**PROJECT NO. R2015-03166-(4) / AVIATION CASE NO. 201500005; AIRPORT LAND USE COMMISSION REVIEW OF SOUTH BAY LEXUS TORRANCE; AUGUST 31, 2016 - ITEM NO. 4**

**STAFF REPORT**  
**SOUTH BAY LEXUS TORRANCE**  
**R2015-03166-(4)**  
**AVIATION CASE NO. 201500005**

**DRAFT FINDINGS AND ORDER OF THE AIRPORT LAND USE COMMISSION  
COUNTY OF LOS ANGELES  
ALUC REVIEW OF THE SOUTH BAY LEXUS TORRANCE PROJECT  
PROJECT NO. R2015-03166-(4)  
AVIATION CASE NO. 201500005**

**SOUTH BAY LEXUS**  
**24777 CRENSHAW BLVD.**  
**TORRANCE, CA 90502**

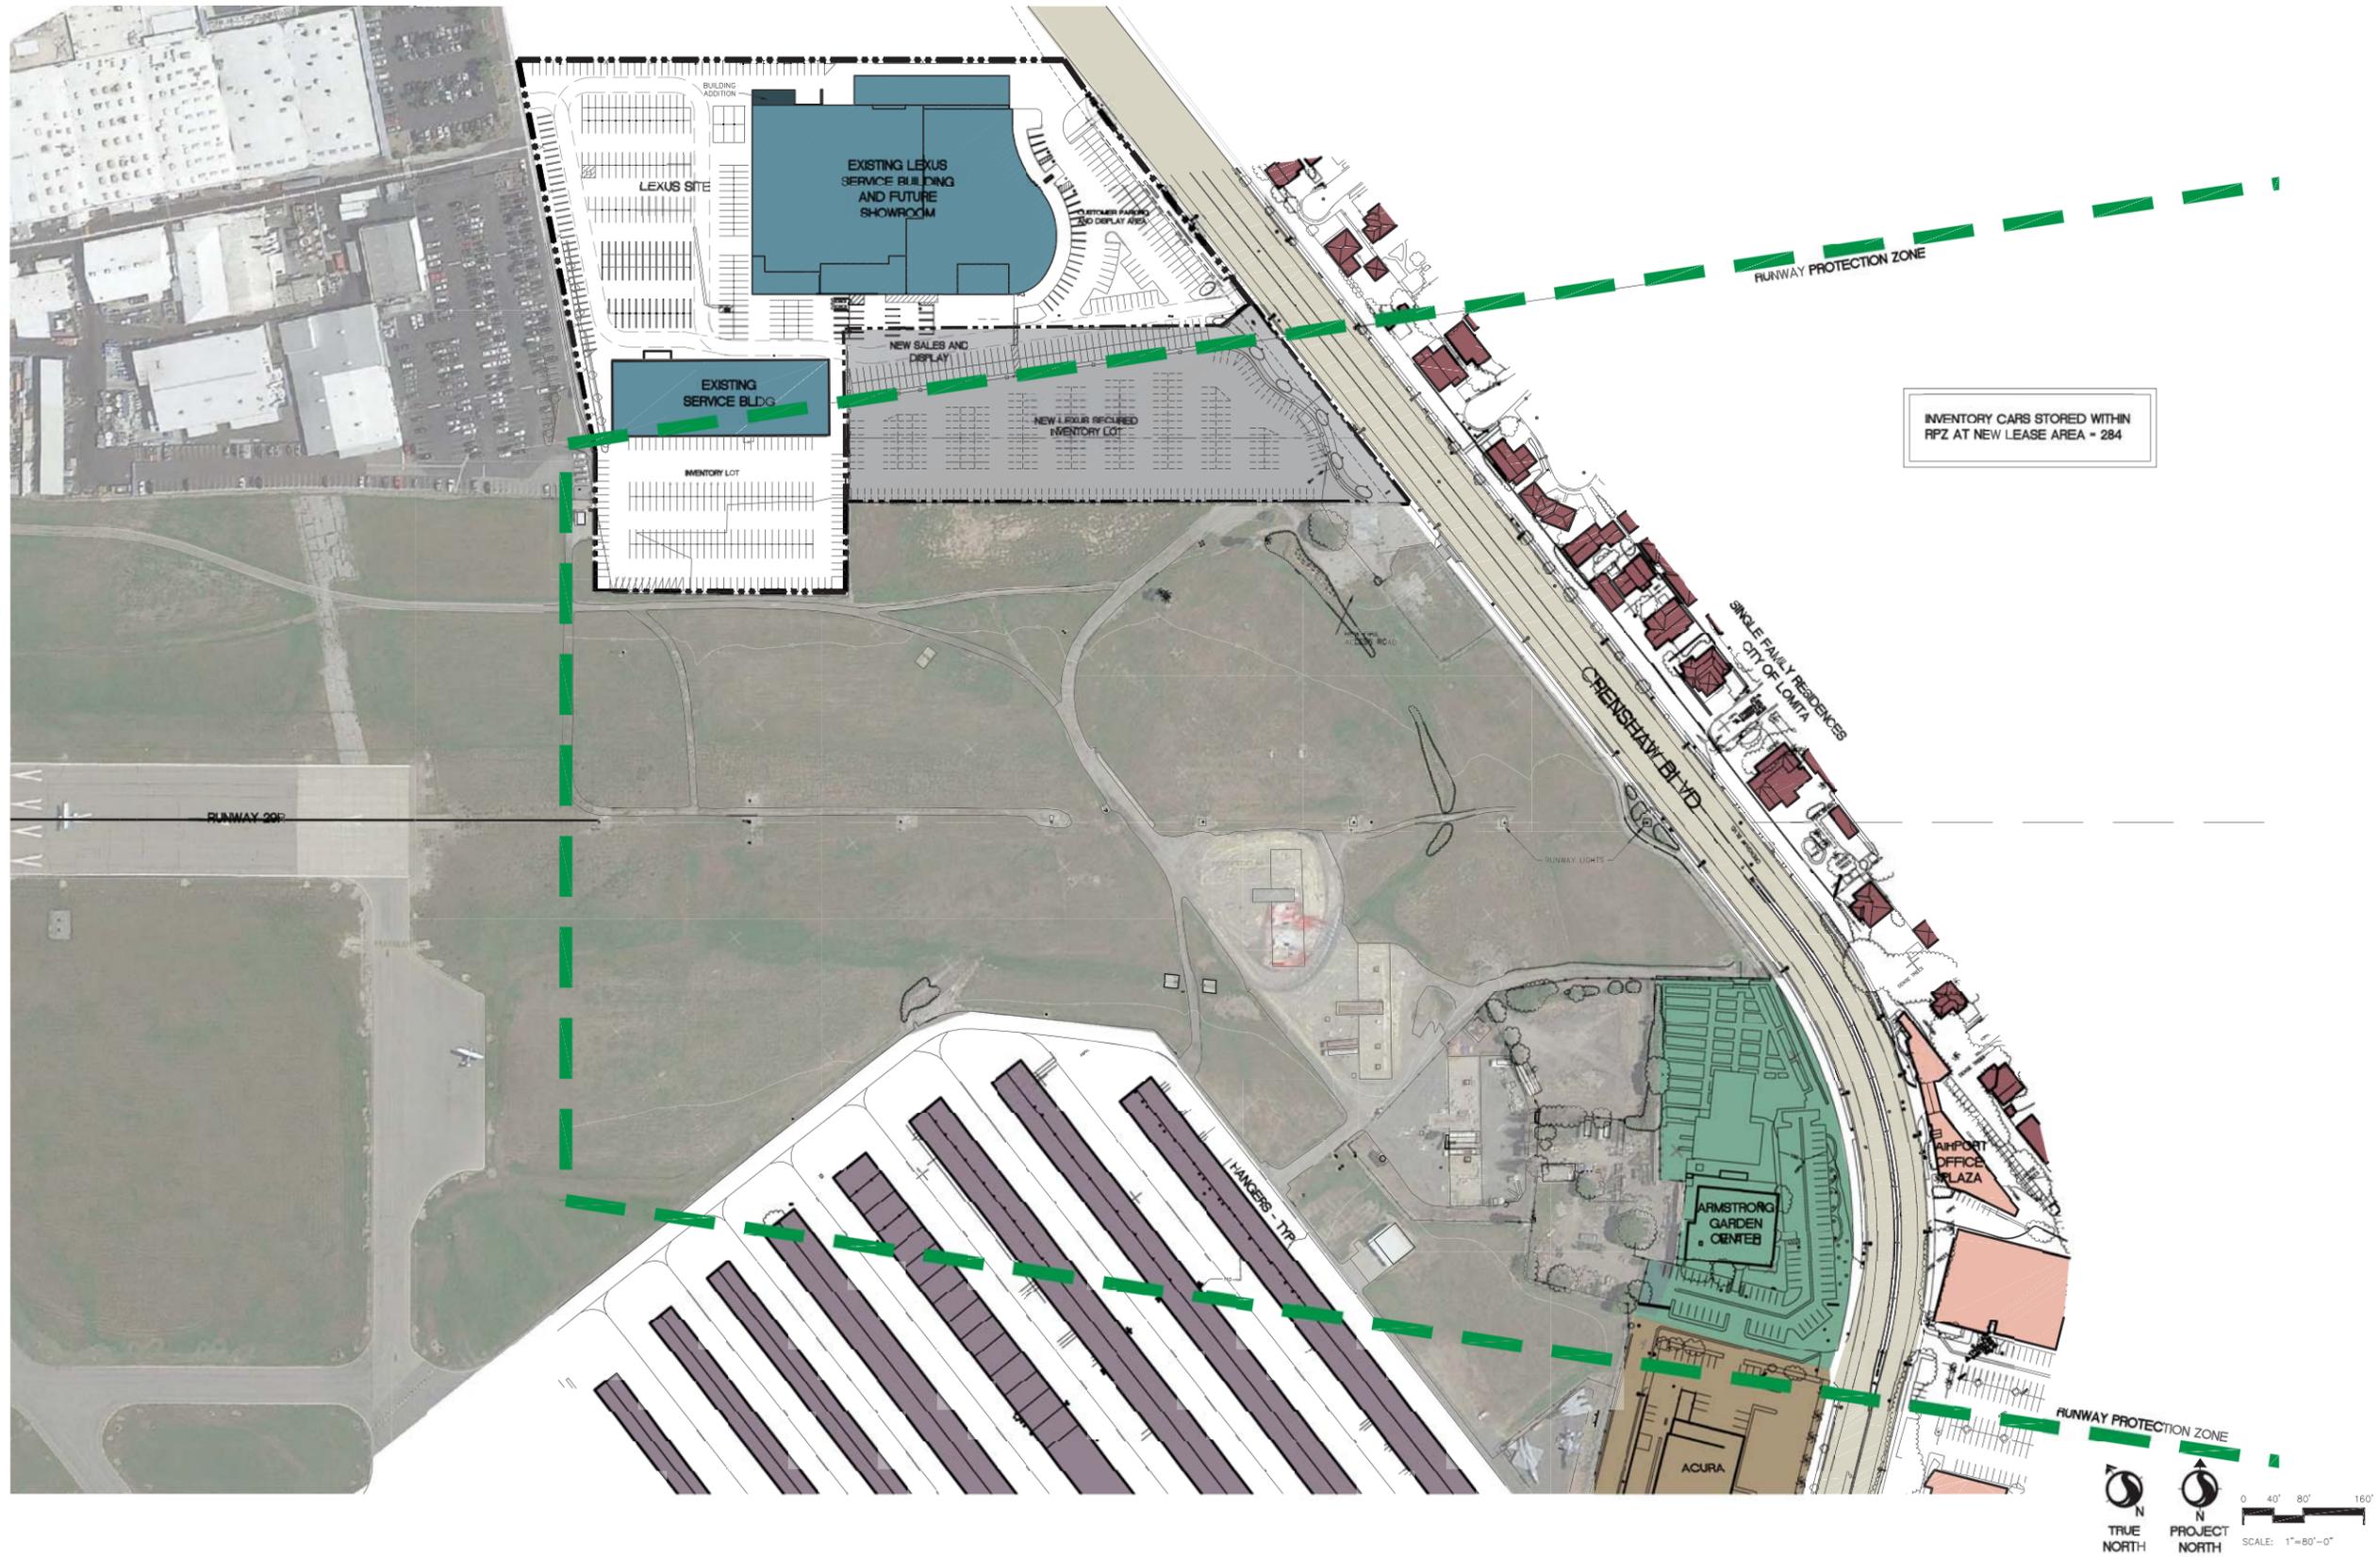
- The portion of the previously proposed sales and display lot that was within the RPZ has been converted to an inventory storage lot, which will be fenced off from the remainder of the dealership and will not be accessible to customers (see Exhibit 1 in **Attachment B**).

- The previously proposed light standards and access driveway that were within the RPZ have been removed from the design, and the site plan revisions have made the potential utility pole/light pole relocation within the RPZ unnecessary (see Exhibit 1 in **Attachment B**).

- Revisions to the site plan to replace the portion of the proposed sales and display lot located in RPZ with a proposed secure inventory lot for storage of vehicles, which will be fenced off, inaccessible to the public and customers, and accessed only occasionally by dealership employees (see Exhibit 1 in **Attachment B**).

- Removal of all street trees from the proposed landscape plan, which were located within the RPZ (see Exhibit 5 in **Attachment B**).
- Alteration of the proposed vehicle circulation plan so that the new driveway will not be located in the RPZ, which will also make the previously discussed potential utility pole/light pole relocation within the RPZ unnecessary (see Exhibit 1 in **Attachment B**).

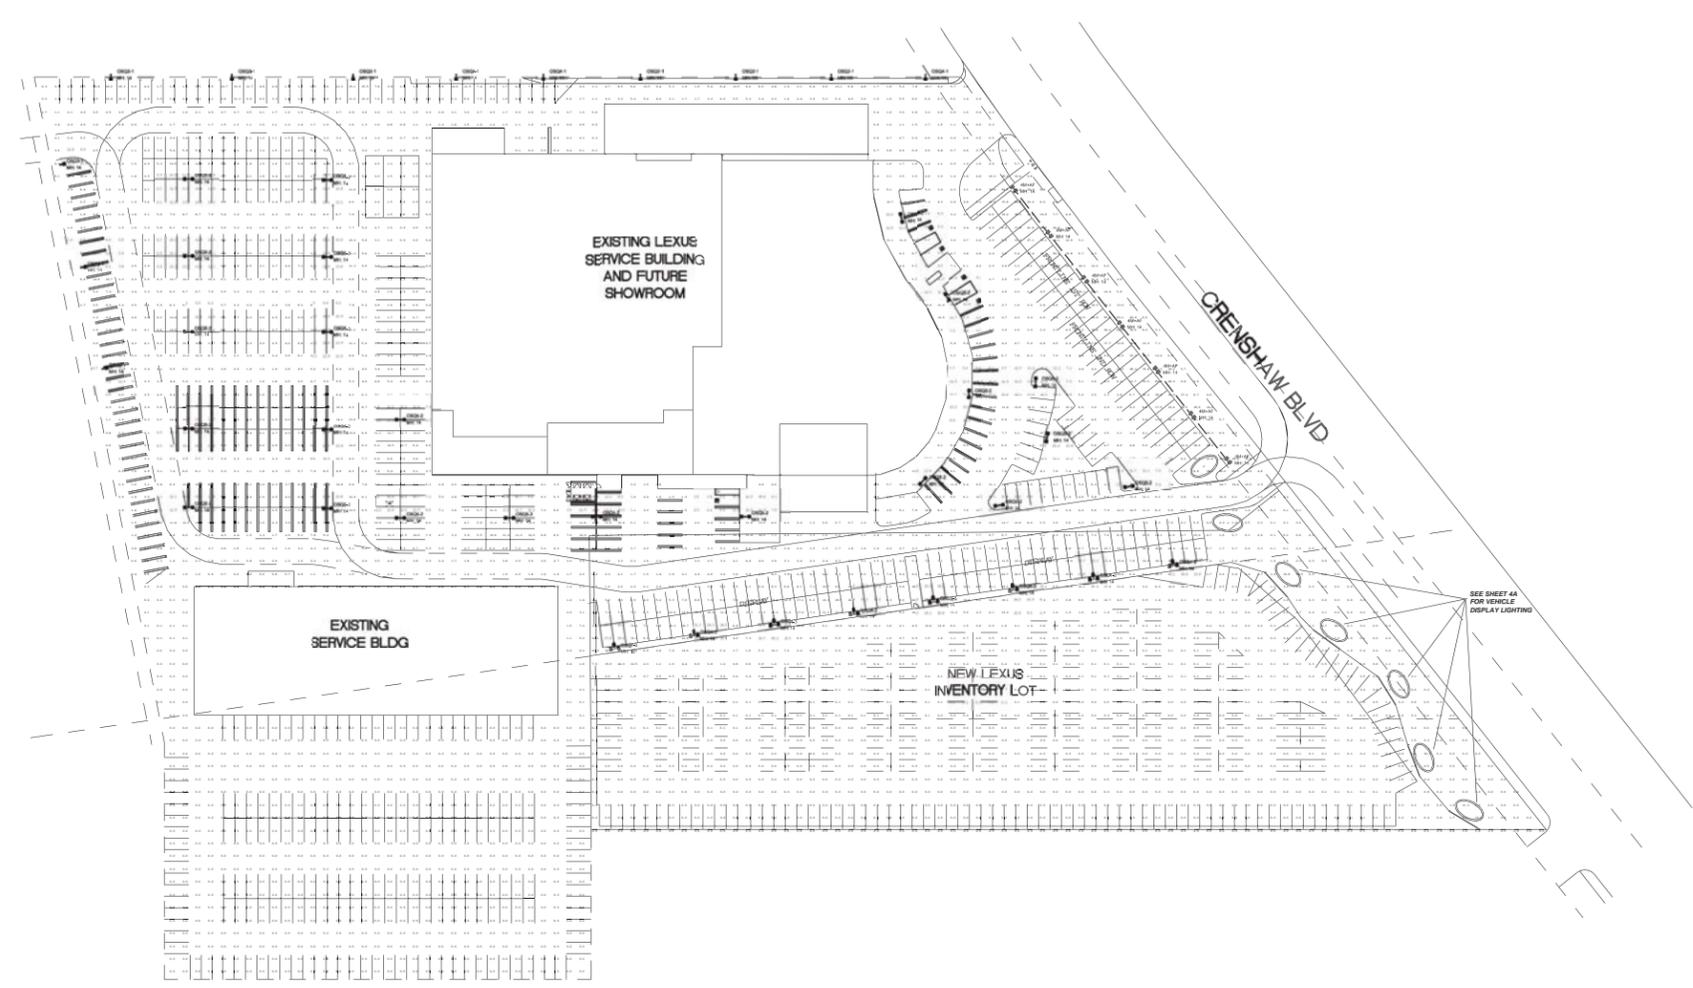
- Provision of lighting details for the vehicle display pads within the RPZ along the Crenshaw Boulevard frontage, which indicate that residual lighting reaching the fenced off portion of airport property will result in less than ½ of a foot candle of spillover occurring over the top of the 8 foot fence (see Exhibit 4A in **Attachment B**).

- Provision of lighting details for the vehicle display pads within the RPZ along the Crenshaw Boulevard frontage, which indicate that residual lighting reaching the fenced off portion of airport property will result in less than ½ of a foot candle of spillover occurring over the top of the 8 foot fence (see Exhibit 4A in **Attachment B**).

NO LIGHTS FIXTURES IN THE PROPOSED INVENTORY LOT IN RFZ

**PLANT PALETTE**

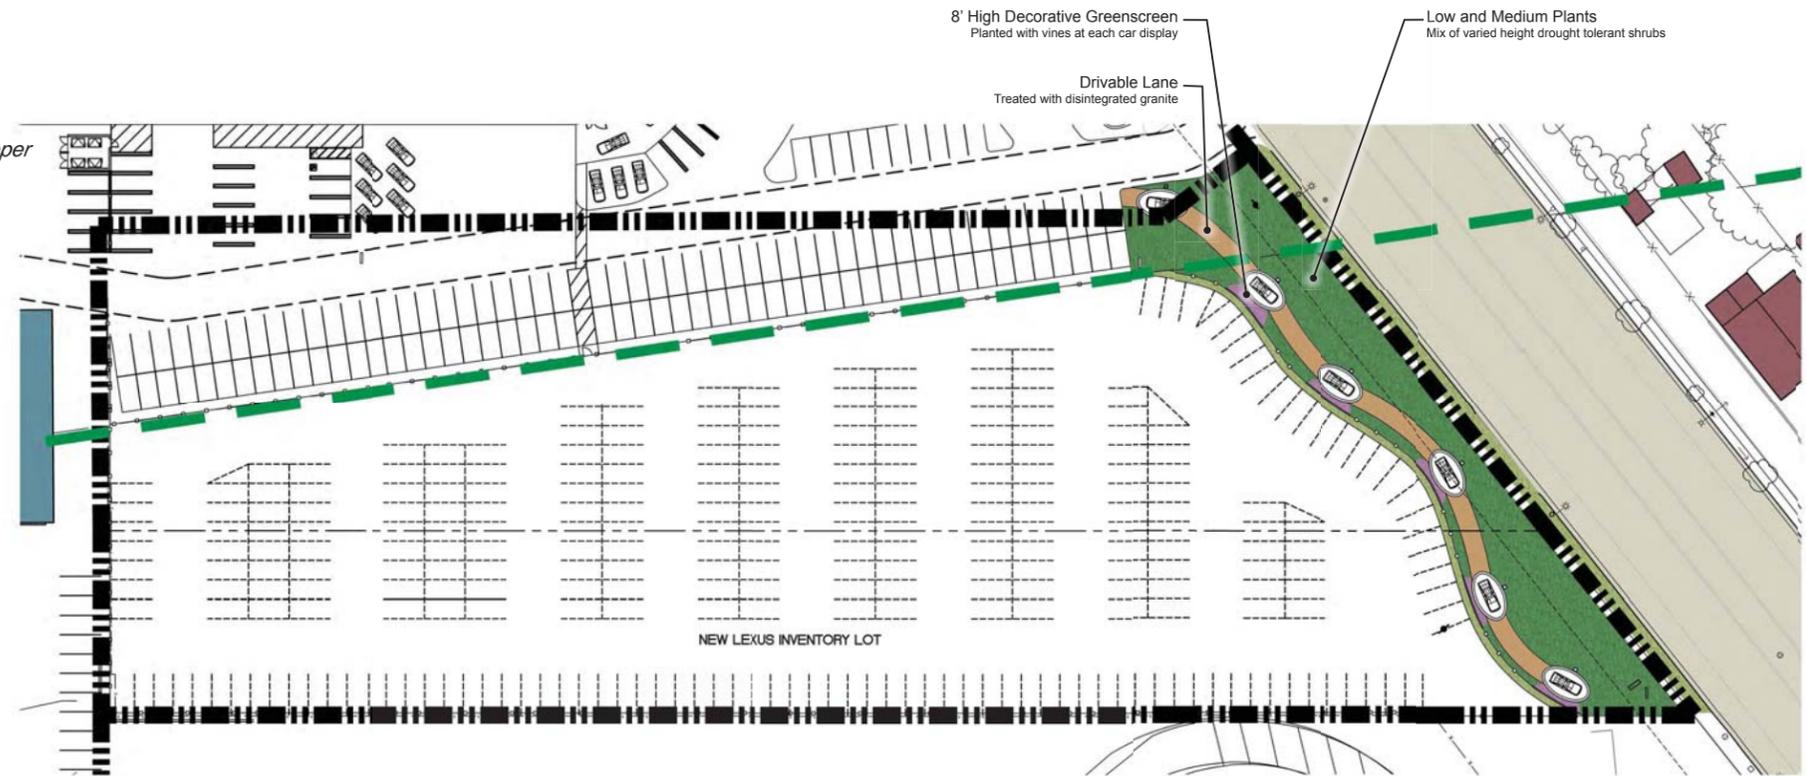
- Street trees that were proposed within the RPZ have been removed from the landscape plan (see Exhibit 5 in **Attachment B**).
- Six vehicle display pads have been added to the site plan along the Crenshaw Boulevard frontage—with five display pads within the RPZ. These raised concrete pads will be lit by ground mounted LED fixtures, and there will be no pedestrian access to the displays (See Exhibit 4, Exhibit 4A, and Exhibit 5 in **Attachment B**).
